# Yates County Planning Board Referral Form

Referral # 2016-58  
County Use Only \_\_\_\_\_

Demolition and rebuild of an existing  
cottage w/ proposed driveway.

Re: Susan Sage site plan

Proposed Site Improvements  
Scale 1"=20'

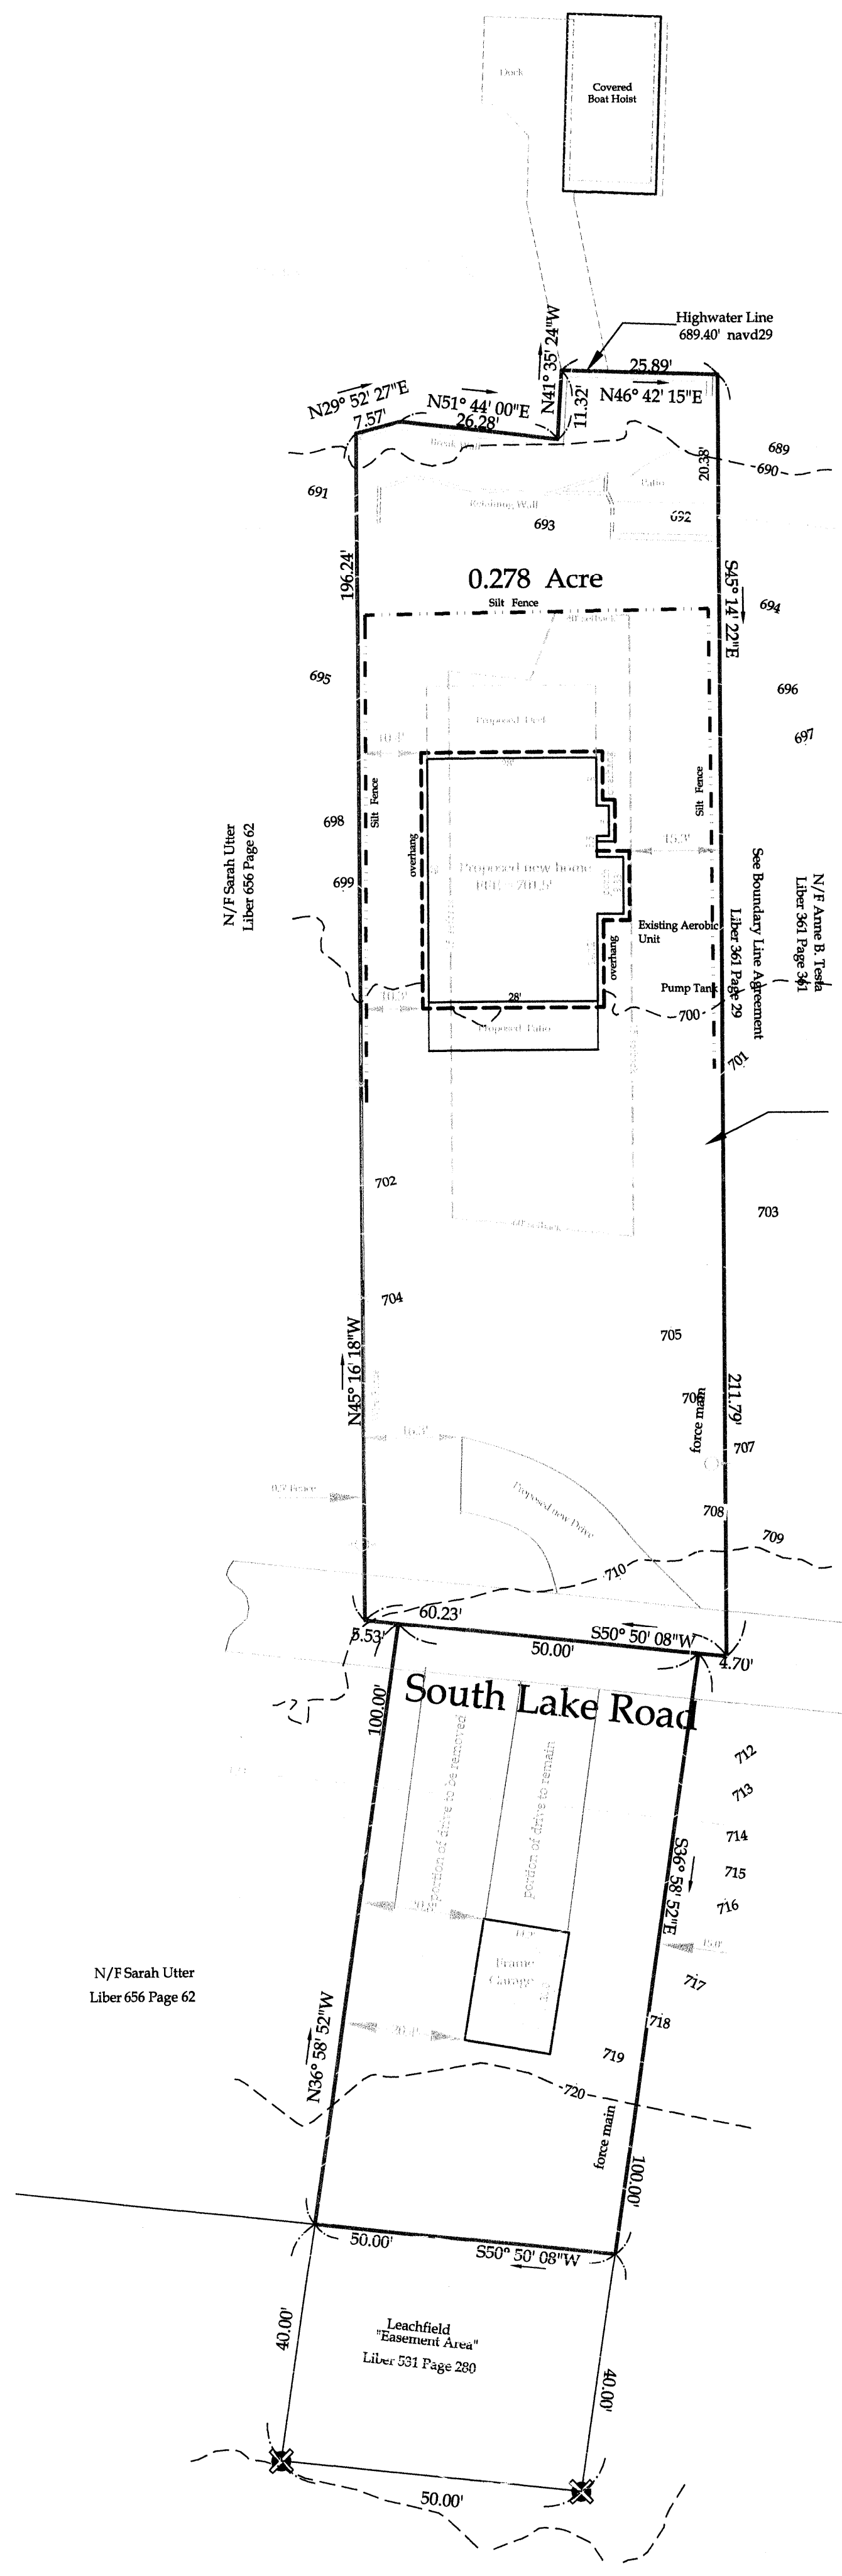
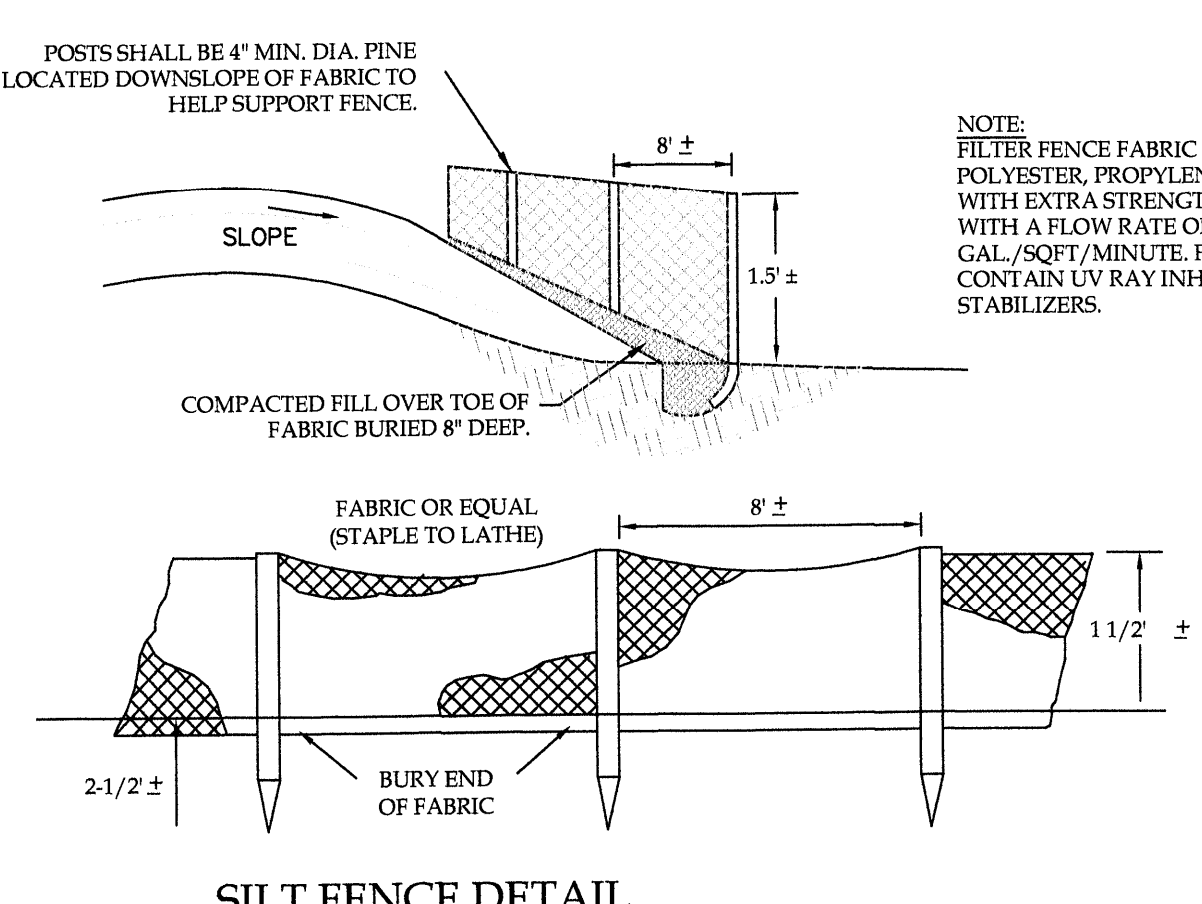
- The plan does not show post construction topographic contours for grading review. This brings up the question of how stormwater will be managed from the proposed driveway and home site. How will runoff controlled so it is not directed to a neighboring property? This would also include roof water.
- The site does not have a stabilized construction entrance for tracking control during construction.
- The plan does not include seeding and mulching information for final or temporary site stabilization.
- The proposed driveway does not show a parking area or turn around. Will this be added to the plan?
- The plan shows retaining walls at the lake. I assume these are existing as no design was included.
